Town of Parker
SALISBURY PARK NORTH - PHASE 1
11700 MOTSENBOCKER RD
PARKER, CO 80134

PHASE 1 DETAILED GRADING & DRAINAGE PLAN

SITE PLAN SUBMITTAL
Page 51 of 311

PHASE 1 STORM PLAN & PROFILE

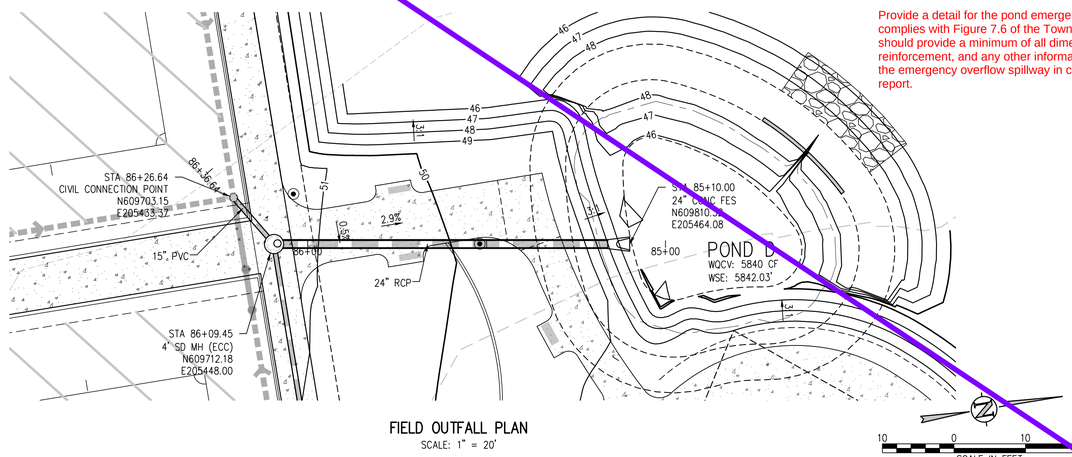
Provide a forebay and a detail for the pond forebay which complies with Figures 7.1 or 7.2 of the Town's SDECM. The detail should provide at a minimum all dimensions, elevations, material, reinforcement, and any other information necessary to construct the forebay in compliance with the drainage report.

Provide a trickle channel and a detail for the pond trickle channel which complies with Figure 7.3 of the Town's SDECM. The detail should provide a minimum of all dimensions, elevations, material, reinforcement, and any other information necessary to construct the trickle channel in compliance with the drainage report.

Please include a Key Map for maps that consist of plan views showing a portion of the overall site

Please show maintenance accesses to infrastructure and provide the Town's maintenance road detail, Figure 7.4 of the Town's SDECM. Identify in plan view the extents of each cross section to be used.

Reference and provide a detail for the pond outlet control structure which complies with Figures 7.5 or 7.9 of the Town's SDECM. The detail should provide a minimum of all dimensions, elevations, material, reinforcement, and any other information necessary to construct the outlet control structure in compliance with the drainage report.

Provide a detail for the pond emergency overflow spillway which complies with Figure 7.6 of the Town's SDECM. The detail should provide a minimum of all dimensions, elevations, material, reinforcement, and any other information necessary to construct the emergency overflow spillway in compliance with the drainage report.

FIELD OUTFALL PROFILE
SCALE: 1"=10' HORIZ
1"=2' VERT

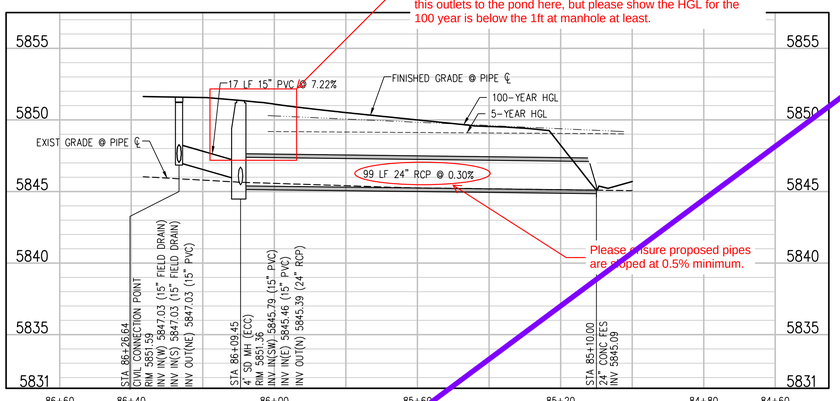
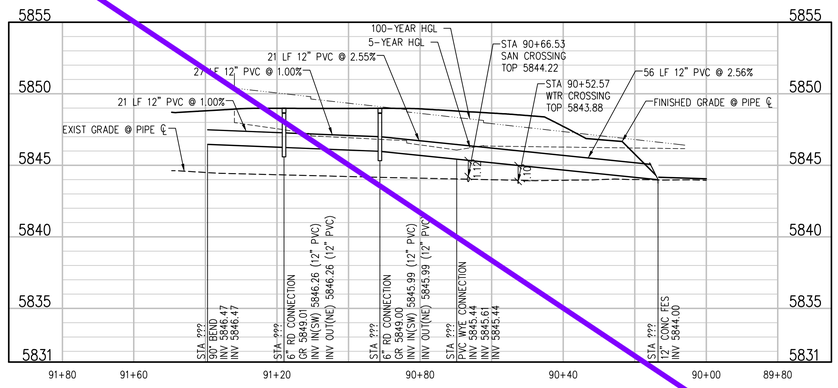
Per the SDECM, In the initial storm event, the hydraulic grade line must be located below the crown of the pipe; In the major storm event, the hydraulic grade must be located 12-inches below finished grade as a maximum condition. Staff understands that this outlets to the pond here, but please show the HGL for the 100 year is below the 1ft at manhole at least.
